# Road Safety Audit Response Report

<b>Report title:</b>	Lye Lane, Bricket Wood, Stage 1 RSA Response
<b>Date:</b>	27/09/22
<b>Document reference and revision:</b>	P2584 Stage 1 RSA Response v1
<b>Prepared by:</b>	Paul Mew Associates
<b>On behalf of:</b>	MRP Planning / JD Rudkin (Builders) Ltd

**Proposed S278 Highway Works**

**Stage 1 Road Safety Audit**

## P2584: Land North of Bricket Wood, Herts Proposed New Footway to South (Page 1 of 4)

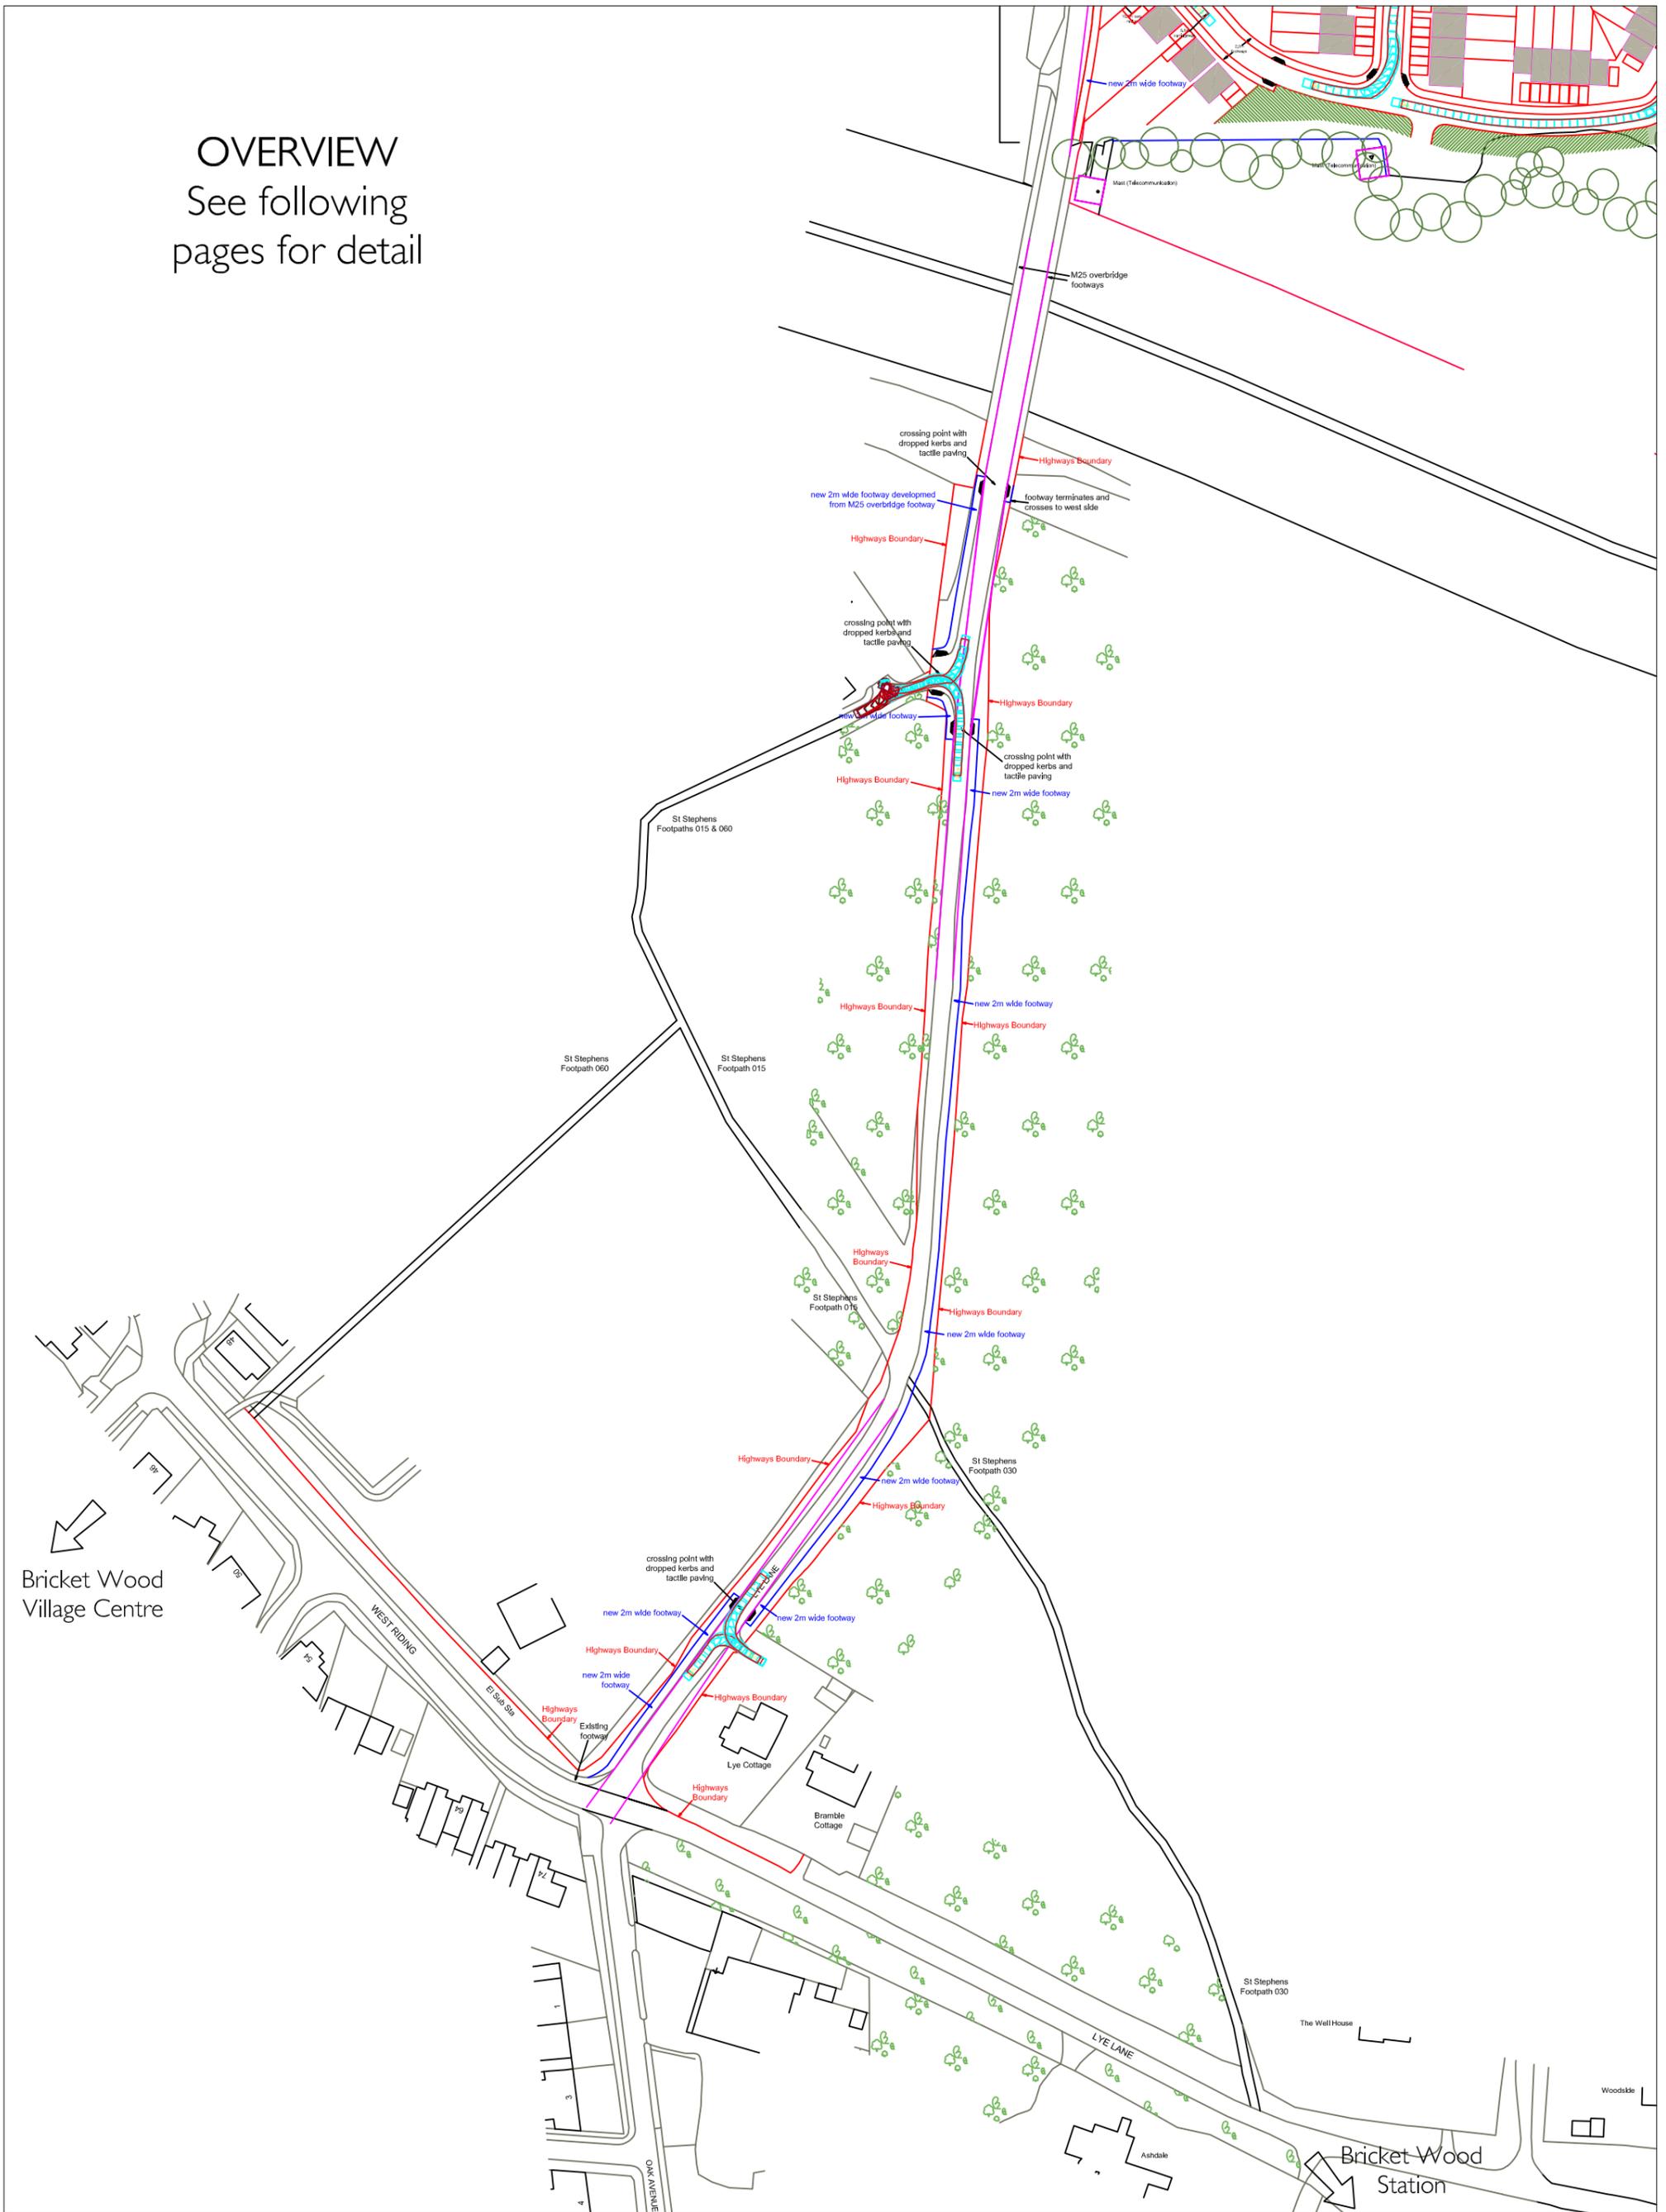
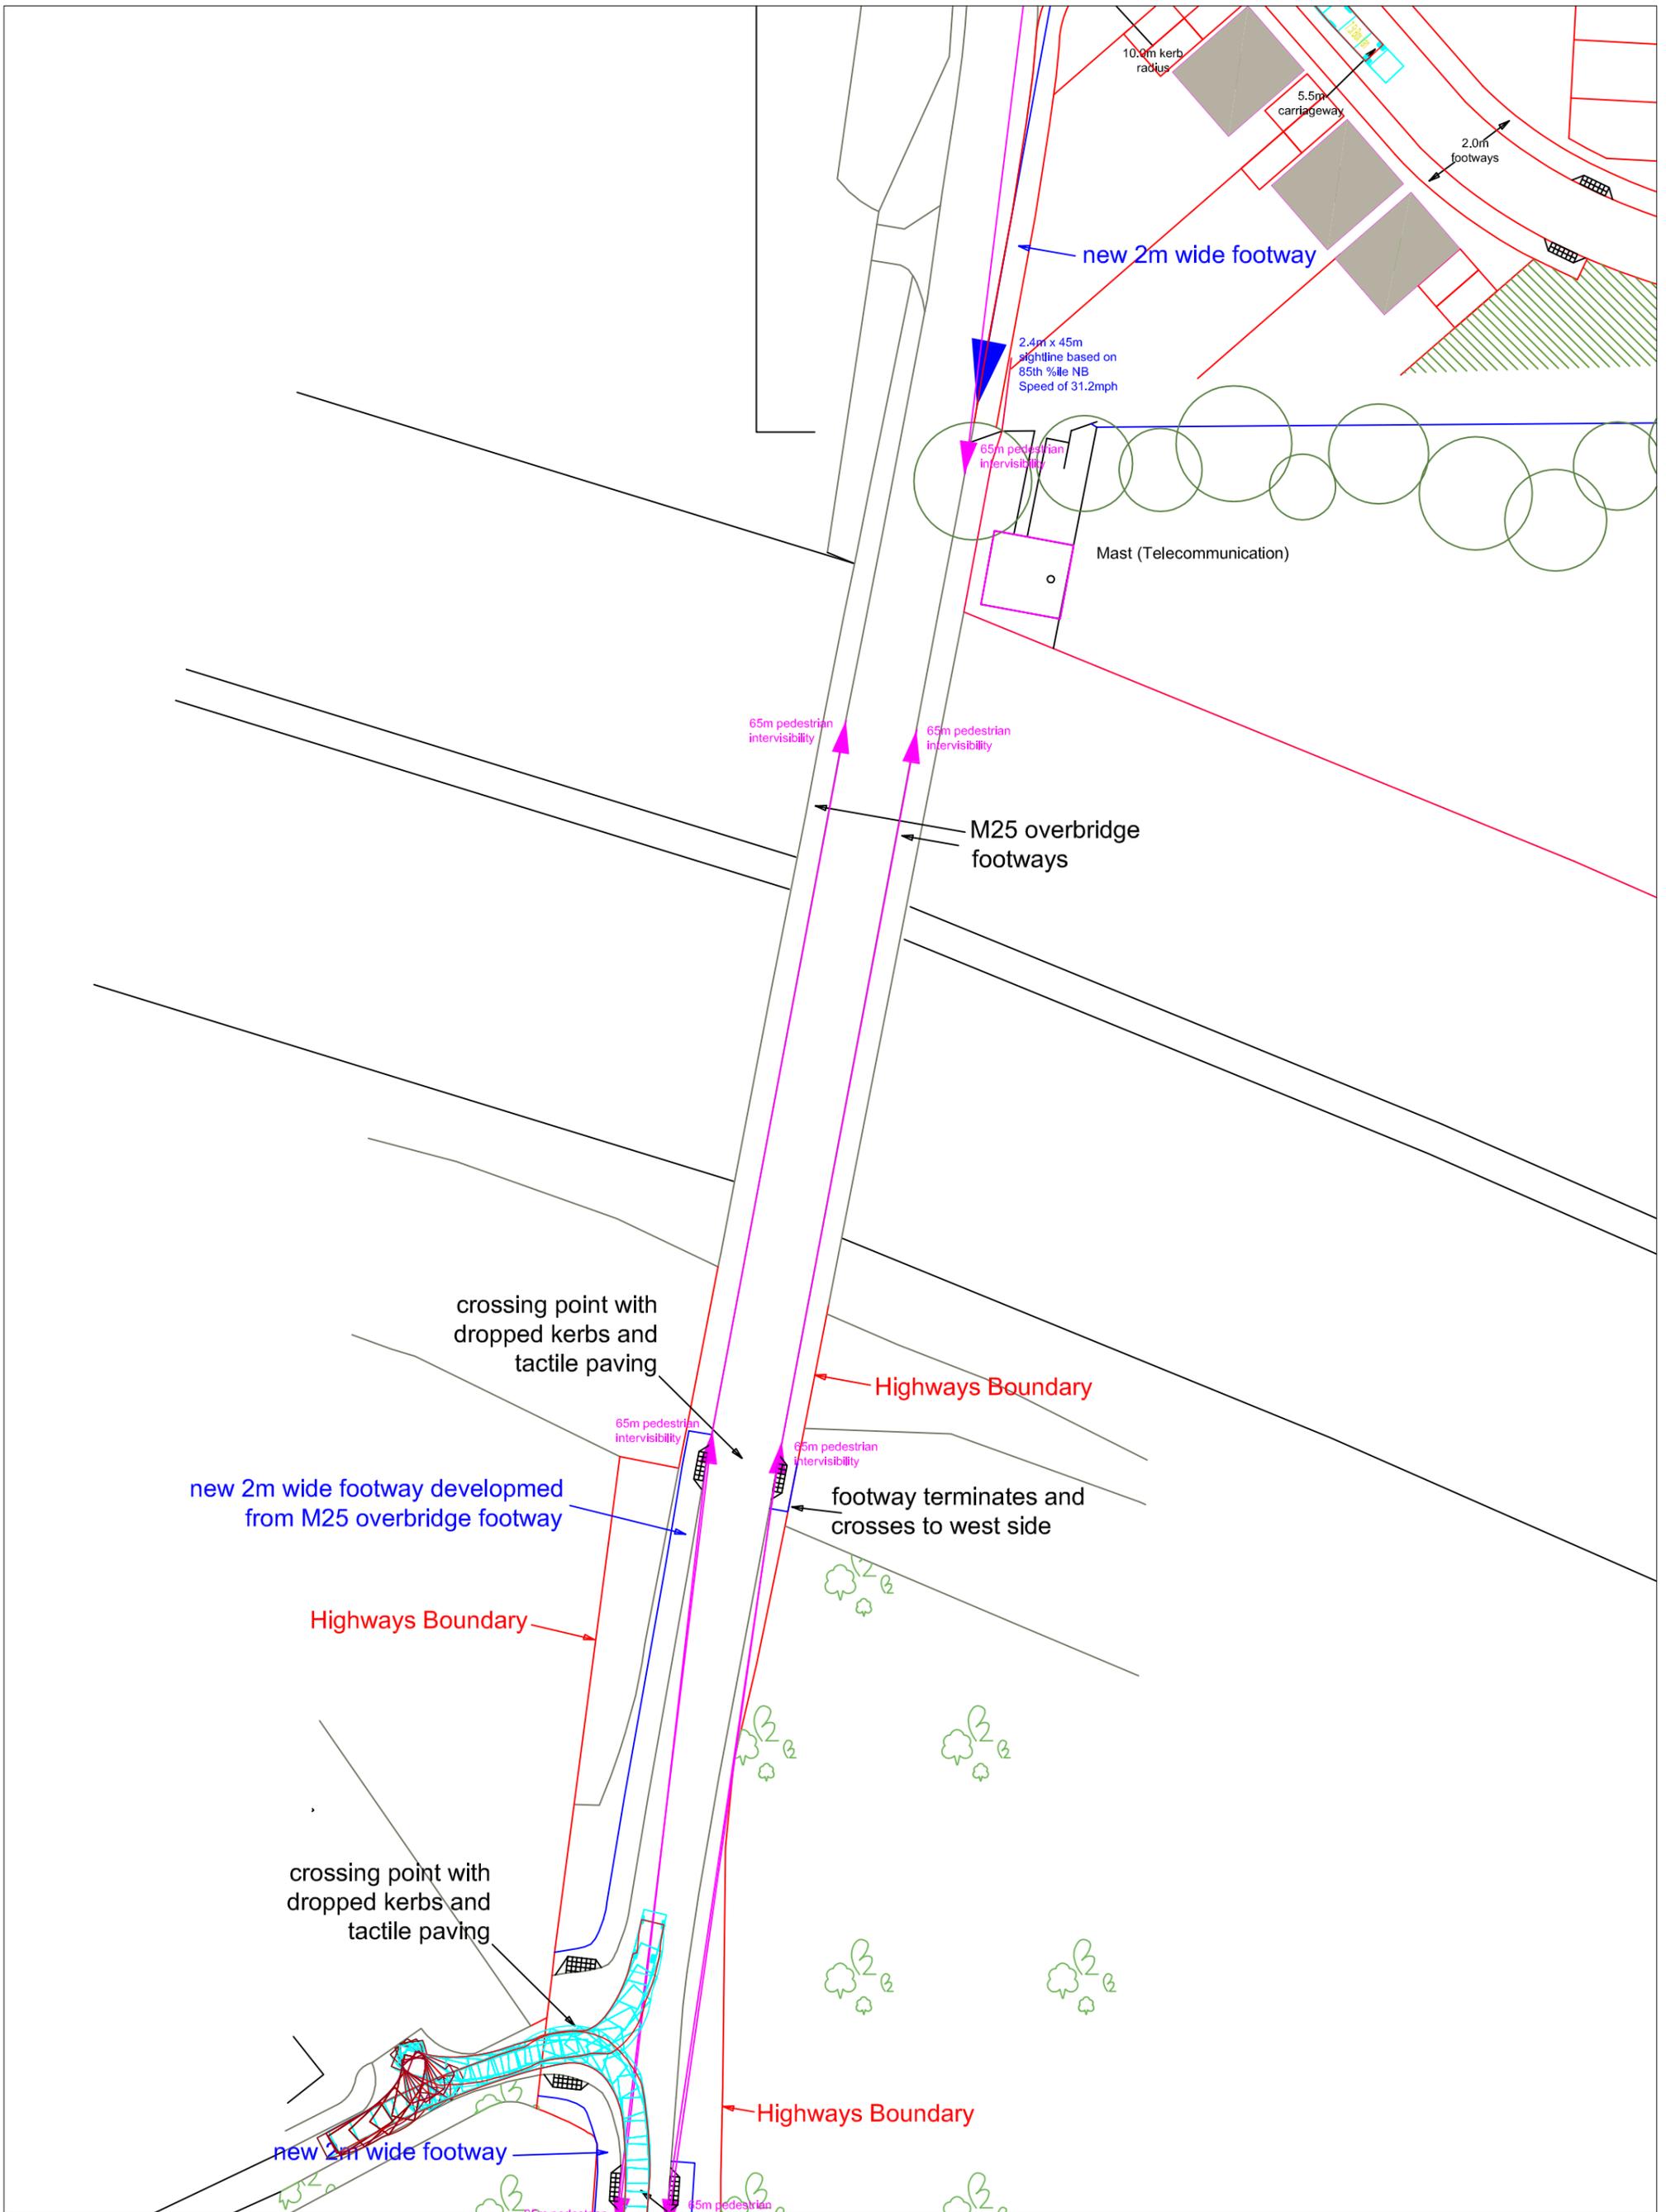
**Locations:** H, I, J, K and L – Crossing provisions south of the proposed development site.

**Summary:** Restricted inter-visibility at the proposed crossing facilities could result in a potential increased risk of vehicular and pedestrian collisions occurring, whereby pedestrians could sustain personal injury.

The site visit has also established the presence of a boundary wall / fence and gate on the northern side of an existing access junction on the western side of Lye Lane, (see Location I within Appendix B), which impacted upon the inter-visibility.

Due to the existing vegetation either side of Lye Lane, concern arises that restricted inter-visibility between pedestrians crossing Lye Lane at these locations and northbound and southbound vehicular traffic could lead to a potential increased risk of vehicular and pedestrian collisions occurring, whereby pedestrians could sustain personal injury.

It is recommended that the inter-visibility at these locations should be accurately measured and kept clear of any impediments that may restrict inter-visibility.

This may necessitate cutting back existing trees, branches and other vegetation on Lye Lane, as well as modifying the crossing provision at the existing access junction on the western side of Lye Lane.

**Location:** P – Lye Lane, reduced footway width.

**Summary:** The proposed narrowed section of footway on the eastern side of Lye Lane could result in a potential increased risk of vehicular and pedestrian collisions occurring, whereby pedestrians could sustain personal injury.

Concern arises that the pedestrians who choose to continue walking on the eastern footway may encounter pedestrians walking towards them on the proposed narrow section of footway, which could result in pedestrians stepping into the mainline carriageway in order to pass one another.

It is recommended that the proposed footway should end to the south of the northern most uncontrolled pedestrian crossing facility, in order to mitigate the above described potential collision scenario.

**Location:** General, throughout the extents of footway provision – Lye Lane, existing ditches.

With the provision of the proposed footways on Lye Lane that would be positioned adjacent to existing verge ditches, concern arises that this situation could lead to a potential increased risk of pedestrian slips and falls occurring into the ditches, especially during the hours of darkness, as Lye Lane is unlit, whereby pedestrians could sustain personal injury.

It is recommended that measures to preclude pedestrians from slipping and falling into the ditches should be provided in order to mitigate the above described potential injury scenario. Measures could include the provision of culverts along Lye Lane or a suitable form of containment fencing to preclude pedestrians from slipping and falling into the ditches.

<p>Locations: H, I, J, K and L – Crossing provisions south of the proposed development site.</p> <p>Summary: Restricted inter-visibility at the proposed crossing facilities could result in a potential increased risk of vehicular and pedestrian collisions occurring, whereby pedestrians could sustain personal injury.</p> <p>The scheme drawing indicates the provision of new footways on Lye Lane between the proposed development site access junction and the junction of West Riding to the south of the proposed development site. The scheme drawing also indicates a number of uncontrolled pedestrian crossing facilities along this section of Lye Lane. The site visit has established there is a notable amount of trees and vegetation either side of Lye Lane between the proposed development site and the junction of West Riding.</p> <p>The site visit has also established the presence of a boundary wall / fence and gate on the northern side of an</p>	<p>It is recommended that the inter-visibility at these locations should be accurately measured and kept clear of any impediments that may restrict inter-visibility. This may necessitate cutting back existing trees, branches and other vegetation on Lye Lane, as well as modifying the crossing provision at the existing access junction on the western side of Lye Lane.</p>	<p>Intervisibility splays will be kept clear of any impediments (planting / vegetation, fencing) over 0.6m above ground level that may restrict visibility at these locations. Pedestrian – vehicle intervisibilities of 65m (in line with 85<sup>th</sup> %ile speeds) can be achieved and are shown in the Revised drawings in Appendix B.</p>

<p>existing access junction on the western side of Lye Lane, (see Location I within Appendix B), which impacted upon the inter-visibility.</p> <p>Due to the existing vegetation either side of Lye Lane, concern arises that restricted inter-visibility between pedestrians crossing Lye Lane at these locations and northbound and southbound vehicular traffic could lead to a potential increased risk of vehicular and pedestrian collisions occurring, whereby pedestrians could sustain personal injury.</p> <p>Additionally, due to the presence of the boundary wall / fence and gate on the northern side of the access junction on the western side of Lye Lane, concern arises that restricted inter-visibility could lead to a potential increased risk of vehicular and pedestrian collisions occurring, whereby pedestrians could sustain personal injury.</p>				
<p>Location: M, N and O – Lye Lane, existing access junction and vehicular crossovers.</p> <p>Summary: Potential swept path requirements of vehicles accessing and egressing the existing access junction and vehicular crossovers on Lye Lane could result in a potential increased risk of vehicular and pedestrian collisions occurring, whereby pedestrians could sustain personal injury.</p> <p>The scheme drawing indicates the provision of new footways on Lye Lane between the proposed development site access junction and the junction of West Riding to the south of the proposed development site. The scheme drawing also indicates a number of uncontrolled pedestrian crossing facilities along this section of Lye Lane. In the event that vehicles overrun the existing verges when accessing or egressing the existing access junction and vehicular crossovers on Lye Lane, concern arises that with the provision of new the footways on Lye Lane this situation could lead to vehicular and pedestrian conflicts occurring.</p> <p>The potential swept path requirements of vehicular traffic accessing and egressing the access junction and vehicular crossovers could result in vehicular traffic overrunning the</p>	<p>It is recommended that swept path analysis exercises should be undertaken for all the expected types and sizes of vehicles using the access junction and vehicular crossovers.</p> <p>Should overrunning of the footways occur, it is recommended that the kerb lines should be modified in order to mitigate the above described potential collision scenario.</p>	<p>Swept path analysis has be undertaken as shown in Appendix B for vehicles turning in / out of the accesses on Lye Lane and demonstrates that they do not over run the proposed footway. It should be noted that swept path analysis has not been carried out for Location N as no vehicle access is provided at this location, rather the location shows a local footpath crossing Lye Lane.</p>

<p>proposed footway areas. As a result, this situation could lead to a potential increased risk of vehicular and pedestrian collisions occurring, whereby pedestrians could sustain personal injury.</p>				
<p>Location: P – Lye Lane, reduced footway width.  Summary: The proposed narrowed section of footway on the eastern side of Lye Lane could result in a potential increased risk of vehicular and pedestrian collisions occurring, whereby pedestrians could sustain personal injury.  The scheme drawing indicates the provision of new 2m wide footways on Lye Lane between the proposed development site access junction and the junction of West Riding to the south of the proposed development site, which include a number of uncontrolled pedestrian crossing facilities. The scheme drawing also indicates a length of footway south of the M25 over-bridge narrows down to 1m before widening out to 2m on the eastern side of Lye Lane.  The site visit has established that there is a vehicle restraint barrier located on the eastern side of Lye Lane south of the M25 over-bridge. Concern arises that the pedestrians who choose to continue walking on the eastern footway may encounter pedestrians walking towards them on the proposed narrow section of footway, which could result in pedestrians stepping into the mainline carriageway in order to pass one another.  The presence of the existing vehicle restraint barrier exacerbates the situation, as the barrier is likely to restrict pedestrians from manoeuvring further east when seeking to pass an opposing pedestrian on this section of footway. As a result, this situation could result in a potential increased risk of vehicular and pedestrian collisions occurring, whereby pedestrians could sustain personal injury.</p>	<p>It is recommended that the proposed footway should end to the south of the northern most uncontrolled pedestrian crossing facility, in order to mitigate the above described potential collision scenario.</p>	<p>The proposed footway has been terminated south of the northernmost uncontrolled pedestrian crossing facility as shown in Appendix B.</p>

<p>Location: General, throughout the extents of footway provision – Lye Lane, existing ditches.  Summary: Location of existing ditches in proximity to the proposed new footways on Lye Lane could result in a</p>	<p>It is recommended that measures to preclude pedestrians from slipping and falling into the</p>	<p>Measures will be provided to preclude pedestrians from slipping and falling into the ditches. These could include the provision of culverts along Lye Lane or other suitable forms of containment fencing.</p>

<p>potential increased risk of pedestrian slips and falls occurring when walking adjacent to existing ditches along Lye Lane, whereby pedestrians could sustain personal injury.</p> <p>The scheme drawing indicates the provision of new footways on Lye Lane between the proposed development site access junction and the junction of West Riding to the south of the proposed development site.</p> <p>The site visit has established the presence of verge ditches running both sides of Lye Lane.</p> <p>With the provision of the proposed footways on Lye Lane that would be positioned adjacent to existing verge ditches, concern arises that this situation could lead to a potential increased risk of pedestrian slips and falls occurring into the ditches, especially during the hours of darkness, as Lye Lane is unlit, whereby pedestrians could sustain personal injury.</p>	<p>ditches should be provided in order to mitigate the above described potential injury scenario.</p> <p>Measures could include the provision of culverts along Lye Lane or a suitable form of containment fencing to preclude pedestrians from slipping and falling into the ditches</p>
